STATE OF DELAWARE  
DEPARTMENT OF TRANSPORTATION  
800 BAY ROAD  
P.O. Box 778  
DOVER, DELAWARE 19903

RE: Agreement No. 2048  
Traffic Impact Study Services  
**Task 7A-Hammond Property**

Johnson, Mirmiran and Thompson (JMT) has completed the review of the Traffic Impact Study (TIS) for the Hammond Property commercial development, prepared by Davis, Bowen & Friedel, Inc. dated November 2011. This review was assigned Task Number 7A. Davis, Bowen & Friedel, Inc. (DBF) prepared the report in a manner generally consistent with DelDOT's *Standards and Regulations for Subdivision Streets and State Highway Access*.

**Site Map**

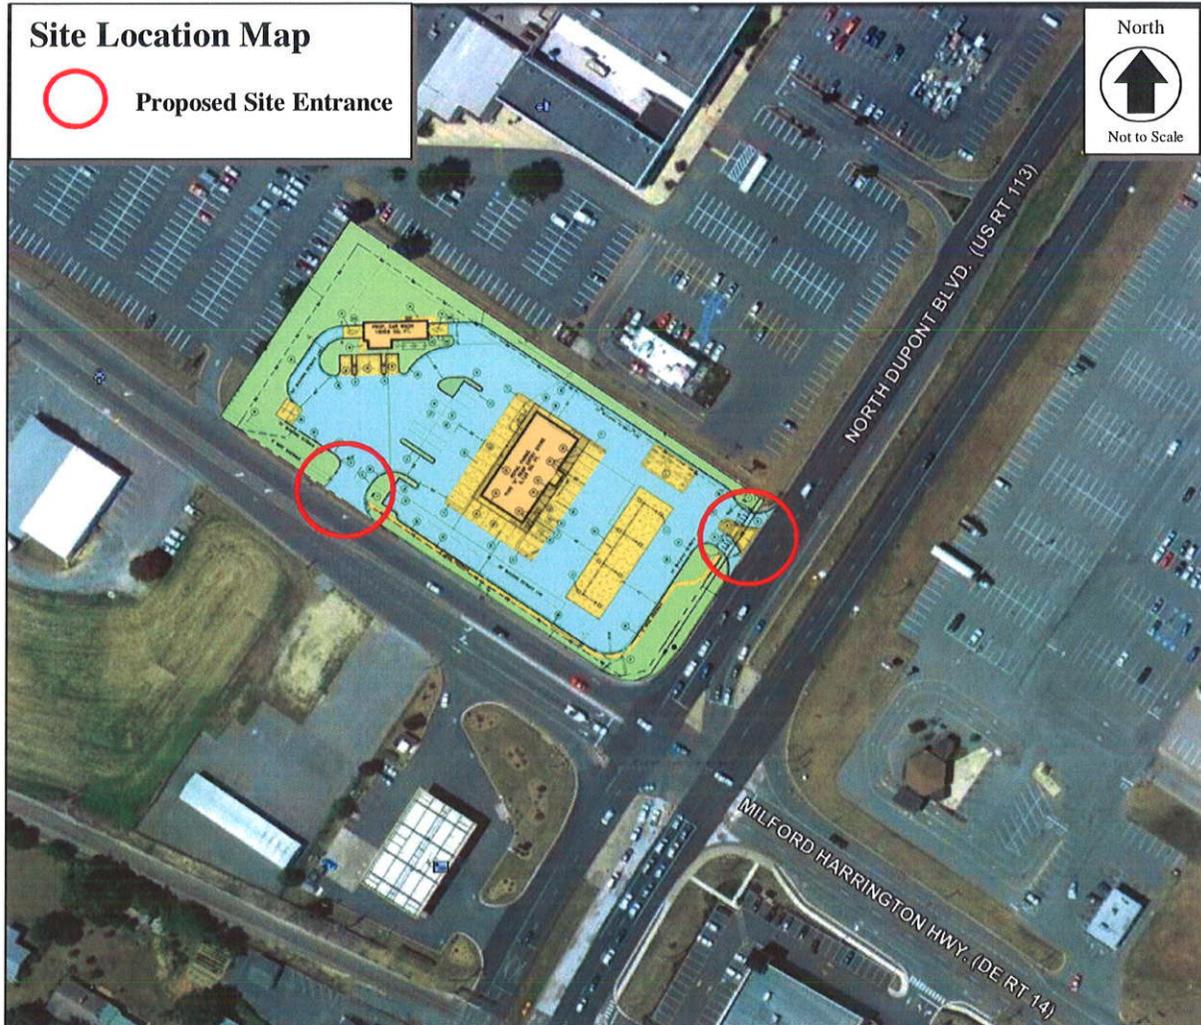
*\*\* The updated project scope now proposes for the construction of a CVS pharmacy with a drive-through window and a drive-in bank instead of the Royal Farms development. An updated Site Plan is not available at this time. As such, the Site Plan prepared for the previously proposed Royal Farms development is shown above.*
